Re: Contra Costa Water District Comments on Bay Delta Conservation Plan and Draft EIR/EIS

Contra Costa Water District
 Comments on the December 13, 2013
 Draft Bay Delta Conservation Plan and Accompanying Draft EIR/EIS

Figure 2-6. Impacts to Los Vaqueros Reservoir illustrated from modeling performed as the basis for BDCP Draft EIR/EIS.

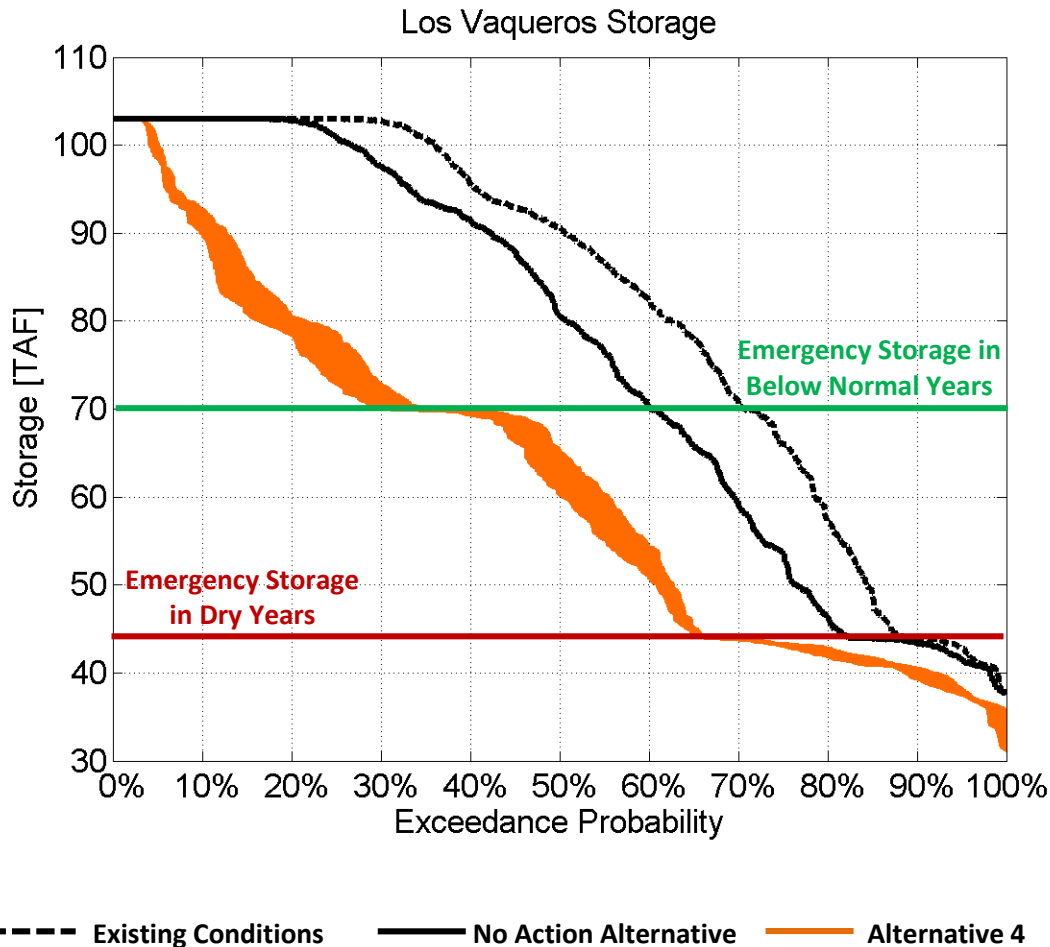
As shown in Figure 2-6, the DWR Preferred Alternative, Alternative 4, would result in significant reductions in storage in Los Vaqueros Reservoir compared to the existing conditions and the No Action Alternative. Without the BDCP, Los Vaqueros Reservoir would be at maximum storage capacity 30% of the time under existing conditions and 20% of the time under the No Action Alternative; with the DWR Preferred Alternative, Los Vaqueros Reservoir would be at maximum storage²⁵ only 4% of the time. Furthermore, without the BDCP, Los Vaqueros Reservoir would remain above the emergency storage level designated for below normal years (70 thousand acre-feet) 70% of the time under existing conditions and 60% of the time under the No Action Alternative; however, the DWR Preferred Alternative would reduce storage such that the reservoir would be above this level only 29% to 34% of the time, depending on the outcome of the BDCP "decision tree" process. The BDCP modeling clearly shows that while other future conditions that may occur without the BDCP, such as climate change and sea level rise, do have an impact on the storage in CCWD's Los Vaqueros Reservoir,²⁶ the BDCP would have a much more significant impact.²⁷

Figure 2-6 and Figure 2-7 illustrate how the DWR Preferred Alternative, Alternative 4, would impact storage in Los Vaqueros Reservoir; similar impacts would be likely to occur under all BDCP alternatives that have significant impacts on chloride concentration at CCWD’s intakes, which includes all of the action alternatives. BDCP Draft EIR/EIS, Executive Summary, Table ES-9 at p. ES-64.

Figure 2-7. Impacts to Los Vaqueros Reservoir based on refined modeling, taking into account biases identified by DWR and correcting the storage capacity of Los Vaqueros Reservoir.

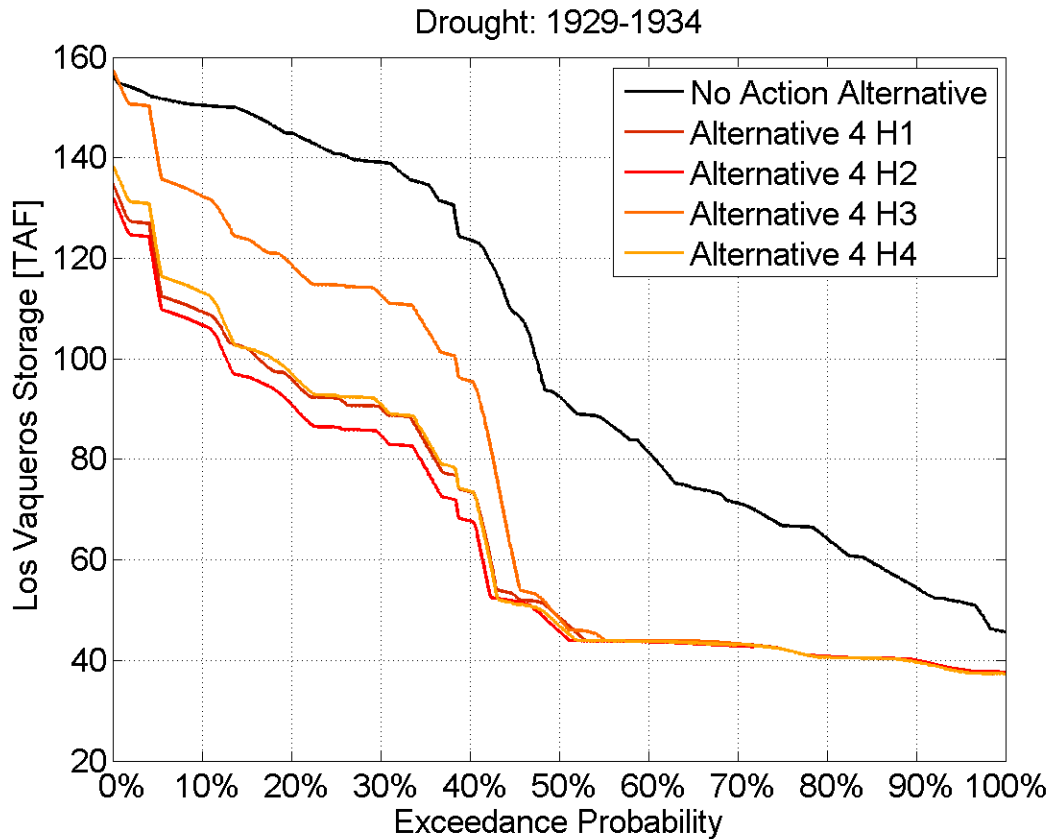
Because neither the modeling performed for the BDCP Draft EIR/EIS nor the subsequent refined modeling performed by DWR staff examined the potential effects on the Los Vaqueros Reservoir for all of the relevant time periods, nor did DWR examine the effects on the existing 160 thousand acre-foot reservoir, CCWD conducted independent modeling to examine the potential effects on its facilities. Following DWR staff's suggestions, CCWD used the Delta Simulation Model II (DSM2) to determine chloride concentration at its intakes, taking into account whether the salinity was from ocean or agricultural salt to determine the amount of chloride in the water. CCWD input this refined water quality data into a model that simulates the operation of CCWD's raw water facilities, including its Delta intakes and Los Vaqueros Reservoir at the reservoir's expanded 160 thousand acre-feet capacity. CCWD's analysis found that the BDCP Alternative 4 would have significant impacts to storage in Los Vaqueros Reservoir, with the most severe impacts occurring during droughts when CCWD water supply is most vulnerable. Figure 2-7 shows the impacts that BDCP Alternative 4 would have on storage in Los Vaqueros Reservoir during a six-year drought that is based on the historical drought from 1929 through 1934. Without the BDCP (in the No Action Alternative), reservoir storage would never reach the level designated for emergency storage in dry years (44 TAF). However, under BDCP Alternative 4, the reservoir would be at or below the emergency storage level approximately 50% of the time during drought conditions.

The volume of water in storage in Los Vaqueros Reservoir is greatly reduced by BDCP Alternative 4 for all possible outcomes of the decision tree (i.e. operational scenarios H1 through H4) during a potential six-year drought. Data source: modeling performed by CCWD following the suggestions of staff at DWR.

Figure 2-8. Percent of years when San Luis Reservoir drops below the “low point” that creates water supply and water quality impacts for certain Central Valley Project contractors

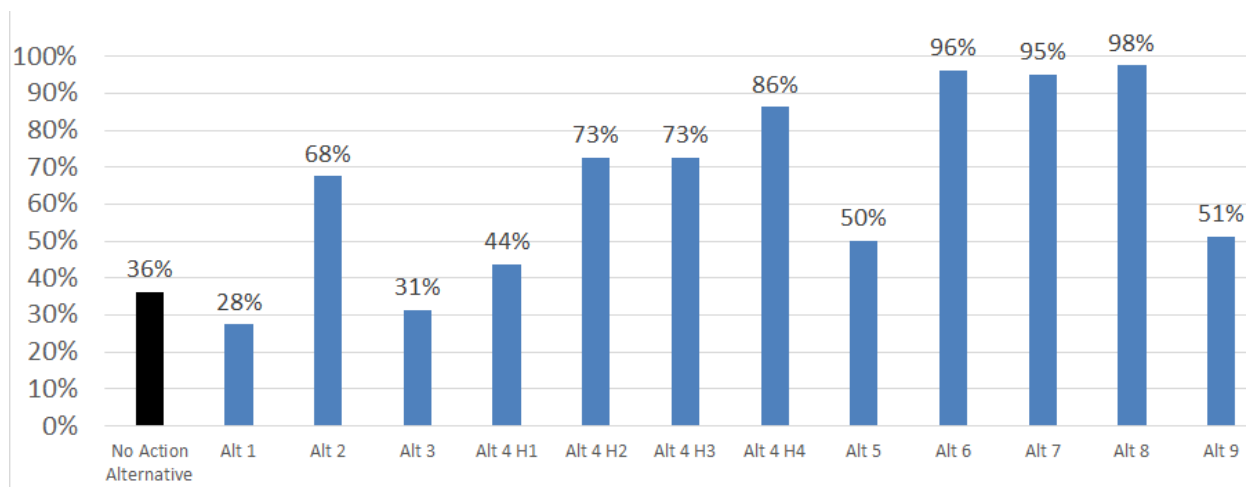
As described in Section 1.1.2, CCWD determined the percentage of time that the water level in San Luis Reservoir would drop below the “low point” by extracting relevant information from modeling that served as the basis for the BDCP Draft EIR/EIS analysis and that was provided to CCWD by DWR (DWR, 2013b). For all alternatives except for Alternatives 1 and 3, the BDCP would exacerbate the San Luis Reservoir low point problem (Figure 2-8). Under the DWR Preferred Project, Alternative 4, storage in San Luis Reservoir would drop below 300 thousand acre-feet in 44% to 86% of the years, depending on the outcome of the decision tree studies, as compared to 36% of the years under the No Action Alternative.

The BDCP would increase the percent of years that would experience impacts related to low storage levels in the San Luis Reservoir for alternatives 2, 4, 5, 6, 7, 8, and 9.

Figure 2-9. BDCP facilities (Alternative 4) with CCWD intakes and pipeline in the south Delta.

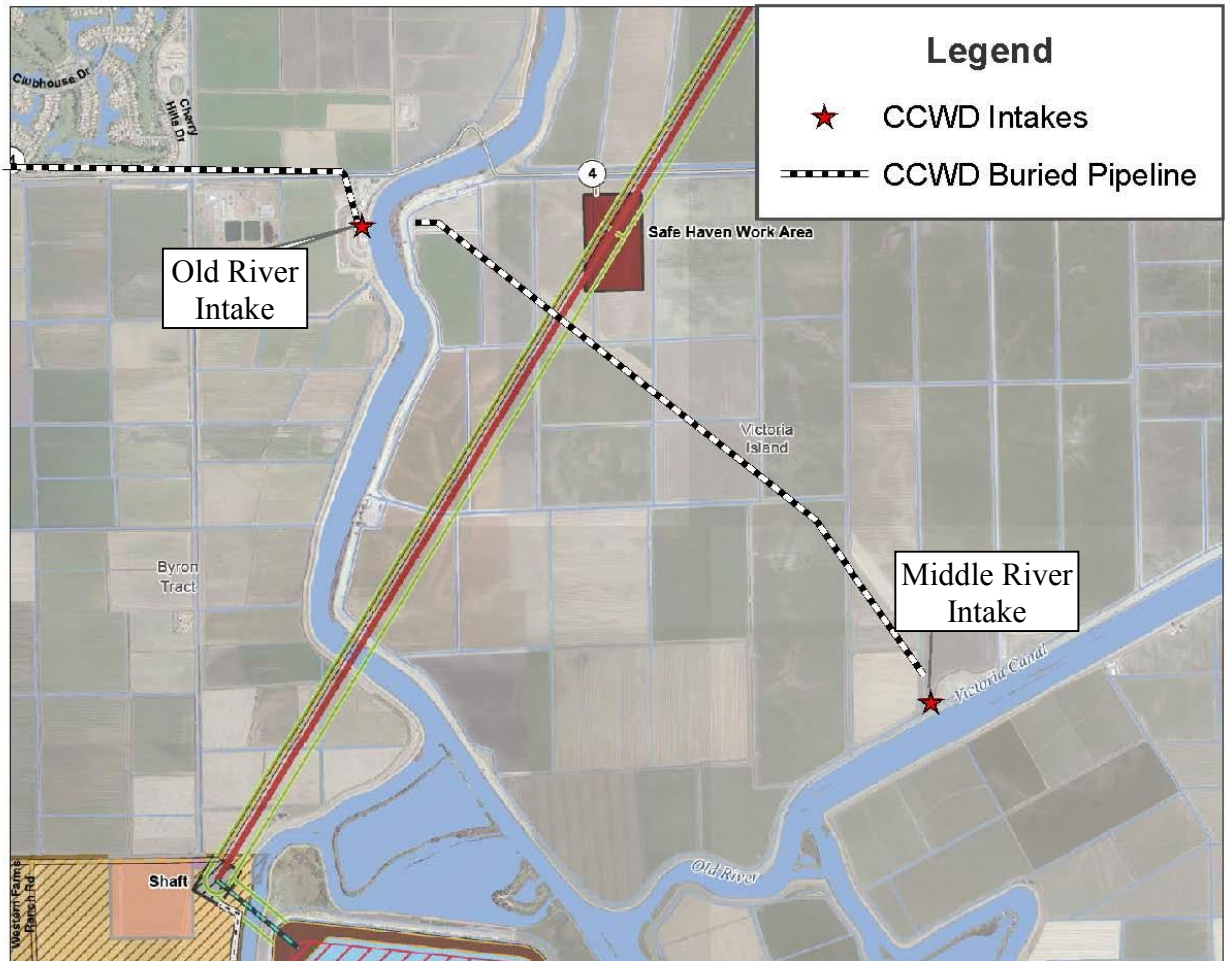
Construction of CM1 in Alternative 1A, 2A, 3, 4, 5, 6A, 7, and 8 would be likely to restrict access to CCWD's existing facilities. The tunnels would cross under the CCWD Middle River Pipeline in Victoria Island and under the Western Area Power Administration power line that was constructed for the Middle River intake. Figure 2-9 below shows CCWD's facilities superimposed on the BDCP facilities. BDCP Draft EIR/EIS, Chap. 3 Mapbook Figure M3-4 (Sheet 11 of 15), and Chap. 13, Mapbook Figure M13-4 (Sheet 6 of 8).

Construction work could interfere with CCWD's routine maintenance access to facilities along the tunnel alignment. Construction at Highway 4 may affect daily access to the Middle River intake and facilities there. Similarly, construction could impair emergency ingress and egress to the intake on the Victoria Island levee road.
